LINCOLN COUNTY Permit # 24-16431

AFFIDAVIT OF WASTEWATER TREATMENT AND DISPOSAL SYSTEM COMPLIANCE REVIEW FOR SYSTEM INSTALLED, REPAIRED OR REPLACED WITHOUT A VALID PERMIT

Address or Location: 42031 US HWY 2, Libby, MT 59923

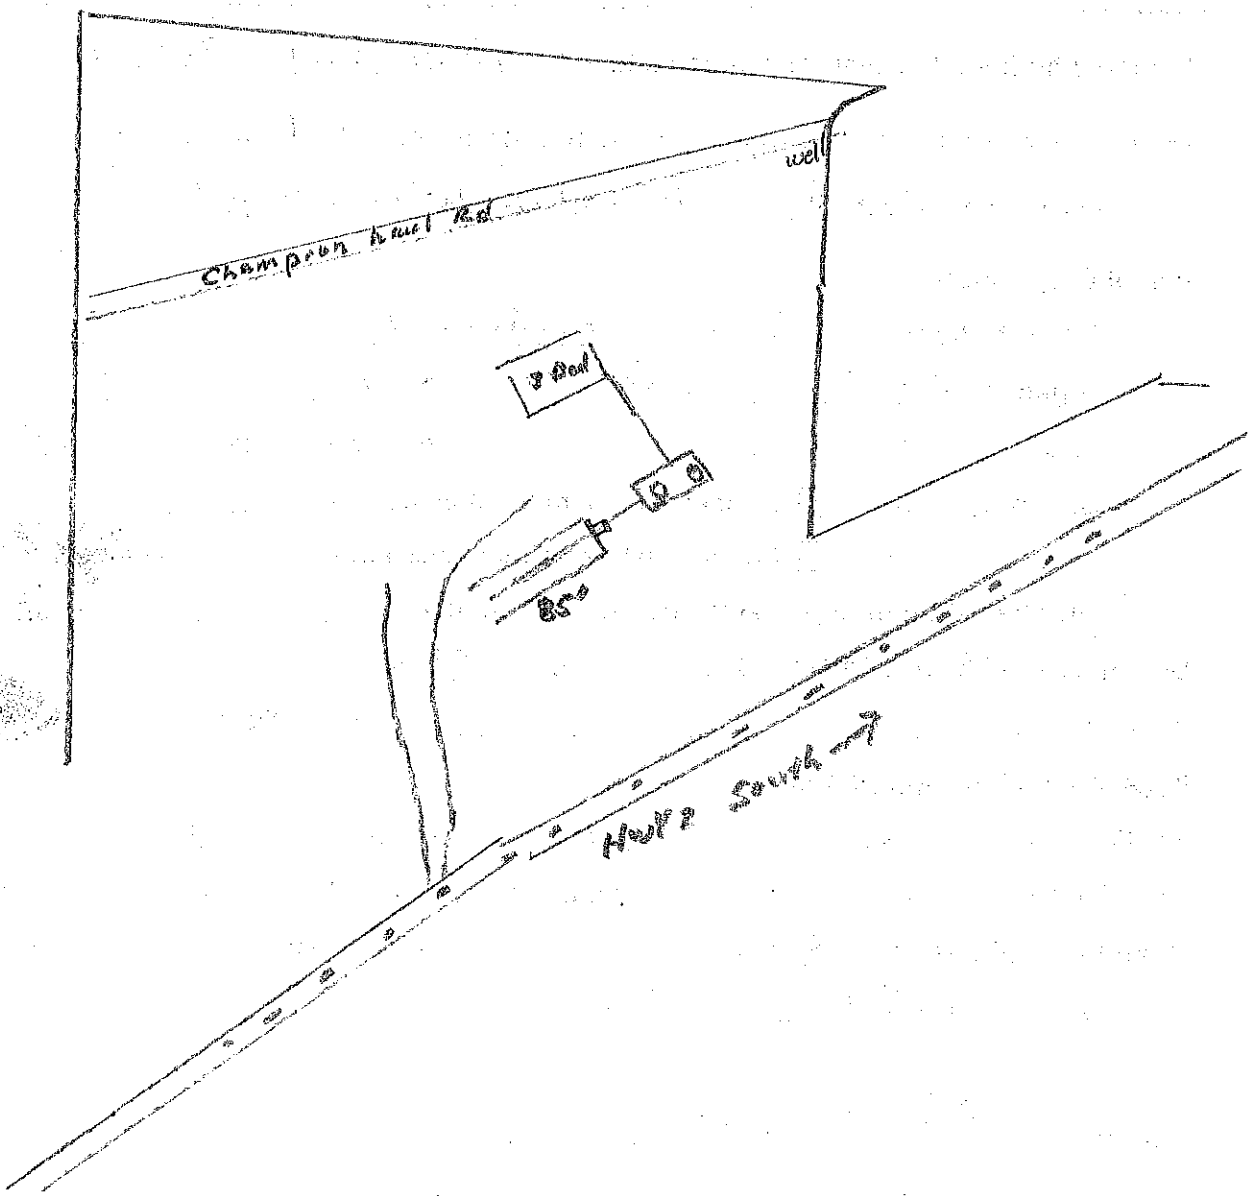
I, Robin Blumberg, have reviewed the components of this system as listed above and found it to be in compliance with the sizing, construction, orientation and operating requirements of Chapter 17, Subchapter 9 A.R.M., Circular DEQ-4 and Lincoln County Wastewater Regulation #3.
